## FA SERIES ELECTRIC/HYDRAULIC SHIFT

Activation Kit No. 43TK3890

## REVISED 8/98 FA SERIES ELECTRIC/HYDRAULIC SHIFT

## **ORIGINAL**

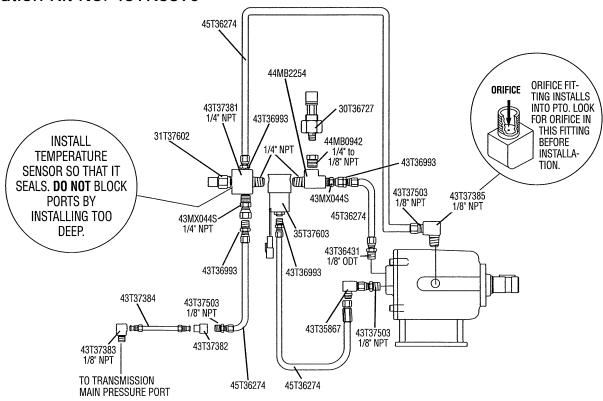
This kit was revised. The transmission elbow was changed and the steel tubing was replaced by rubber hose. If your Kit has a steel tube, then use the above diagram for installation. There is no performance difference with either Kit. Both Kits are installed with the same wiring harness supplied in the PTO carton.
